ADDENDUM # 002

RE: Cherokee Nation Entertainment
Tahlequah Casino

- Item 1** Addendum #002 Summary of Changes
- Item 2** Revised Plumbing Drawings
- Item 3** Revised ITS101 and ITS102

Description of Revisions Narrative

SHEET NUMBER:
PU1.1

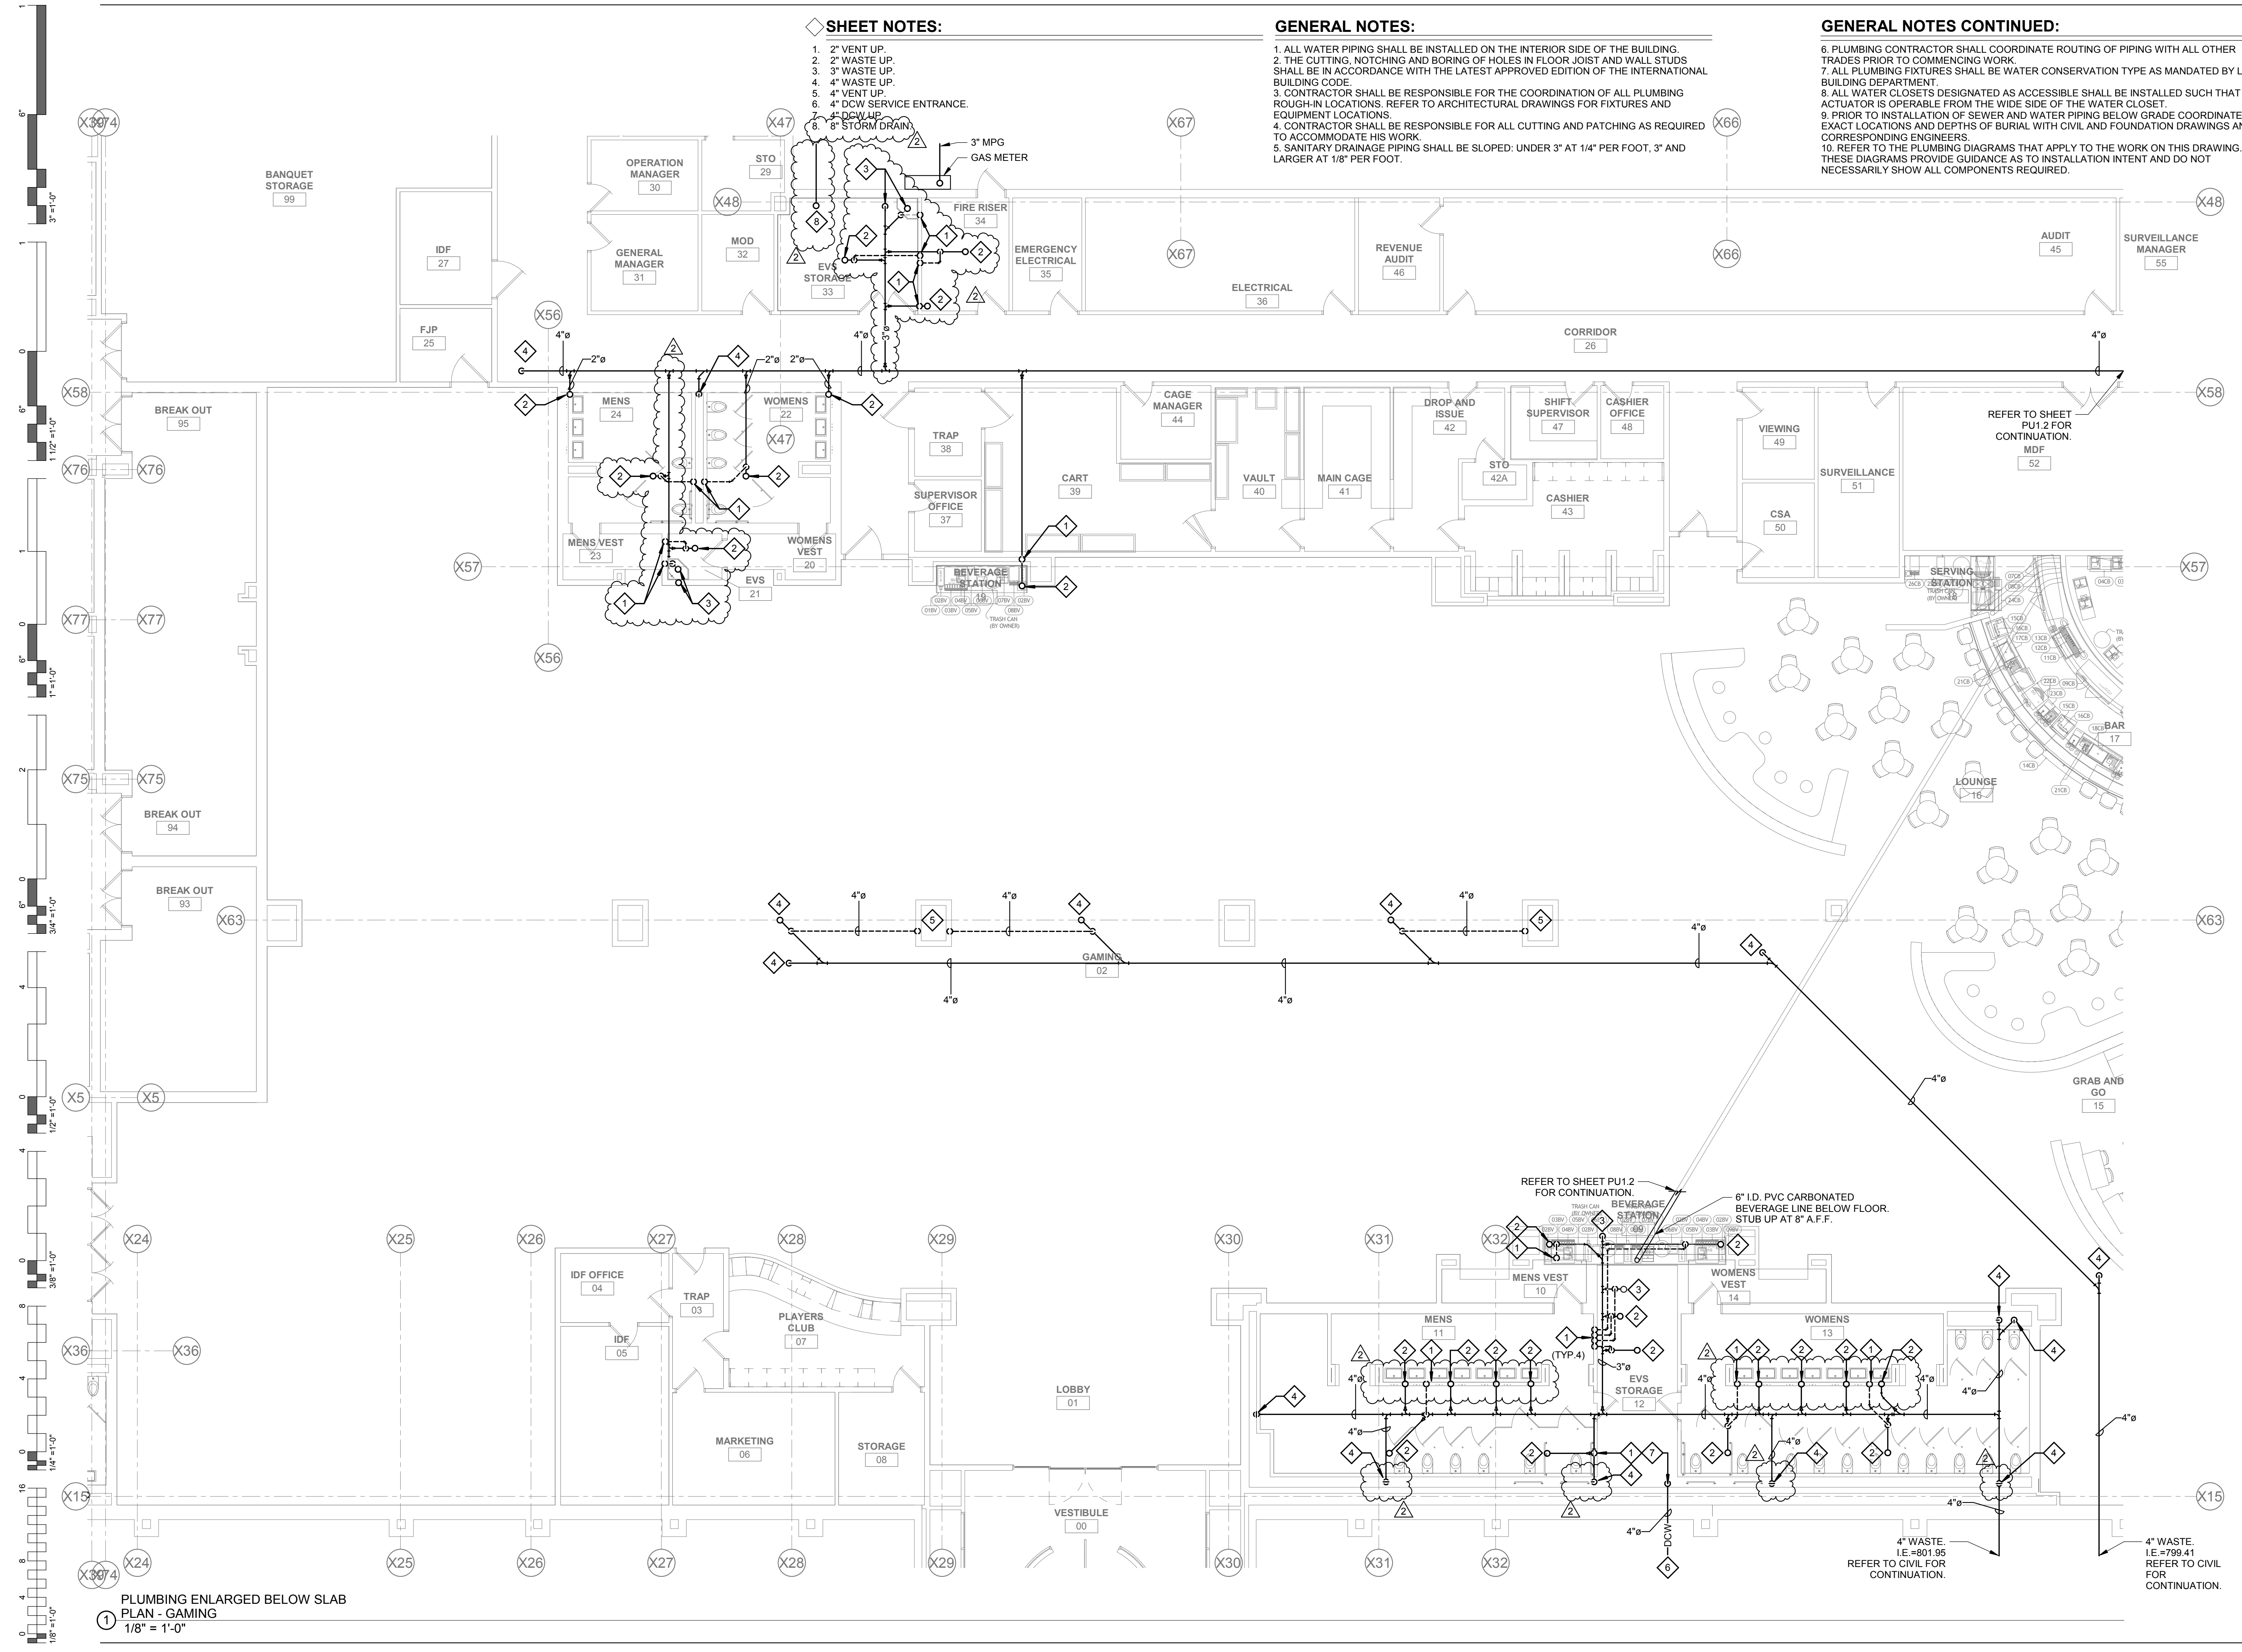
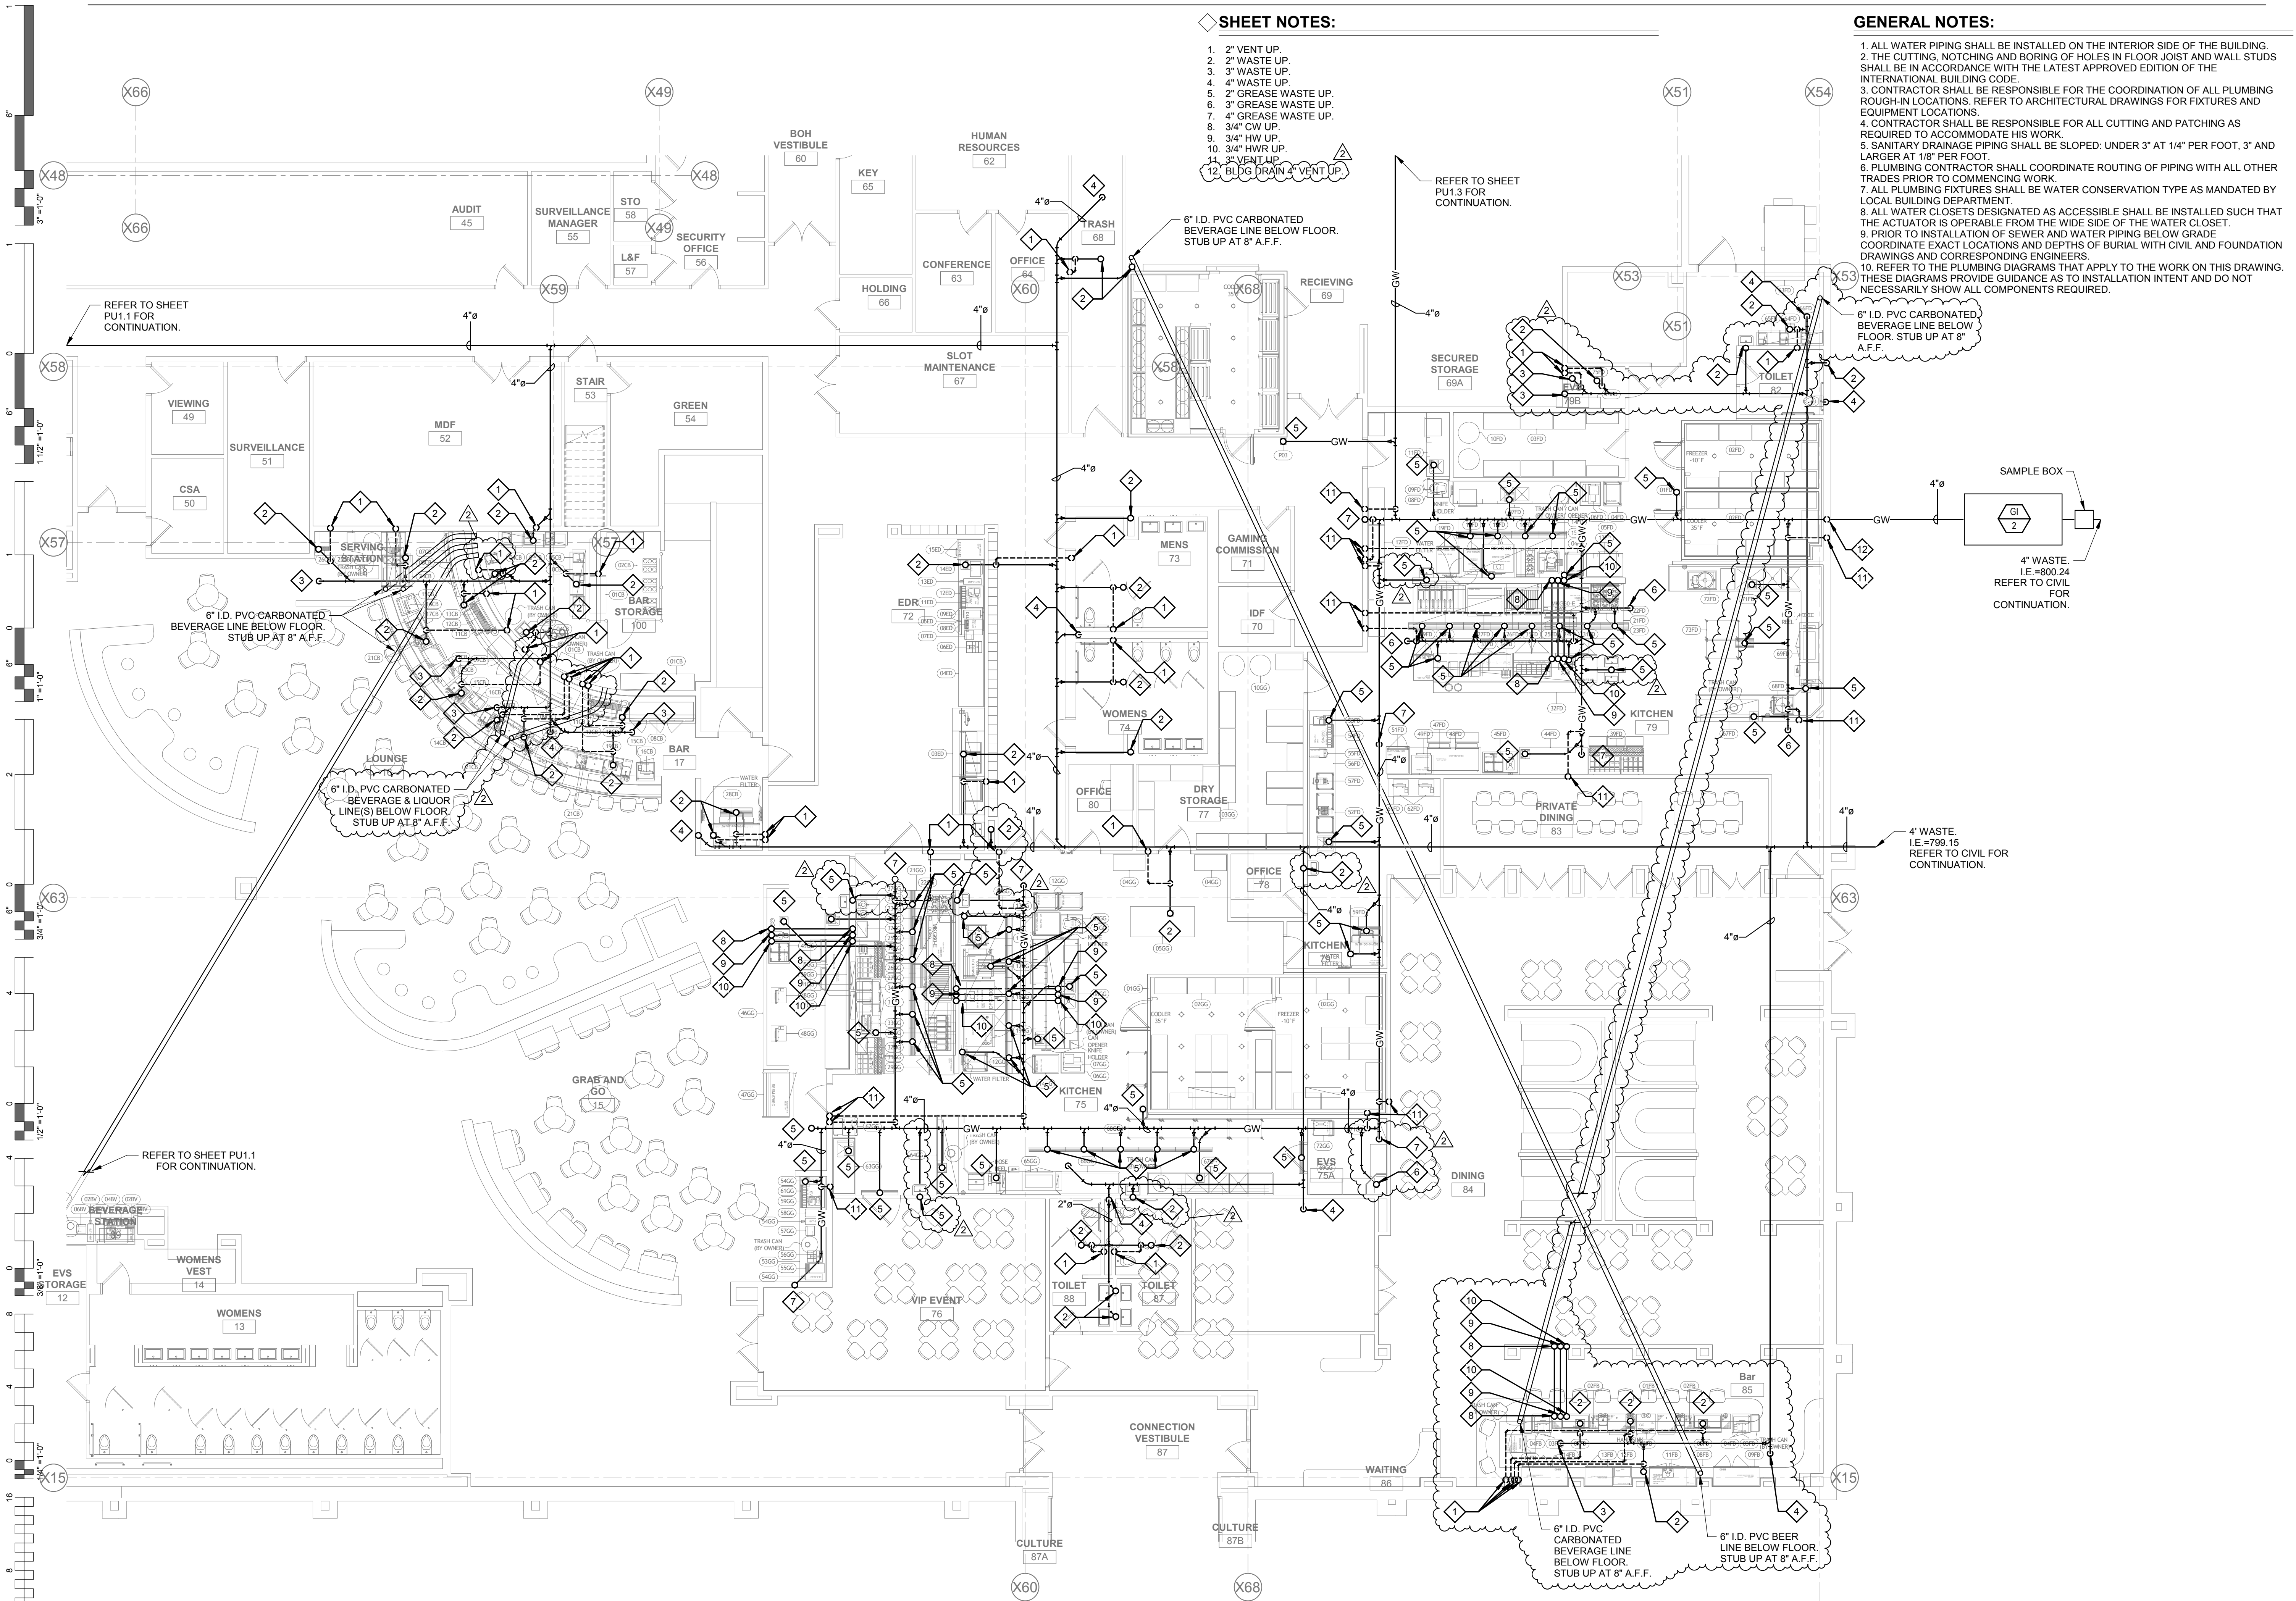
<u>Sheets</u>	<u>Description</u>
PU1.1	Added (1) 8" Storm drain penetration / floor drain / mop sink to EVS Storage 33. Added floor drain / mop sink EVS 21. Moved waste and vent lines into architectural wall shift in Mens 11 & Womens 13. Added floor drain / sink to Fire Riser 34.
PU1.2	Added carbonated beverage/liquor lines in Bar 17. Extend waste/vent lines to hand sinks in Kitchen 75 & 79. Added mop sink & floor drain to EVS 79B and mop sink to 79A. Relocated vent lines to consolidated column in Bar 85. Added carbonated beverage lines to Bar 85.
PU1.3	Added (2) 8" storm drain penetrations.
PU1.4	Extend waste/vent lines to hand sinks in Banquet Food Preparation 98. Added (3) 8" storm drain penetrations.
PU1.5	Added (2) 4" storm drain penetrations. Added mop sink and floor drain to EVS 91 & 93.
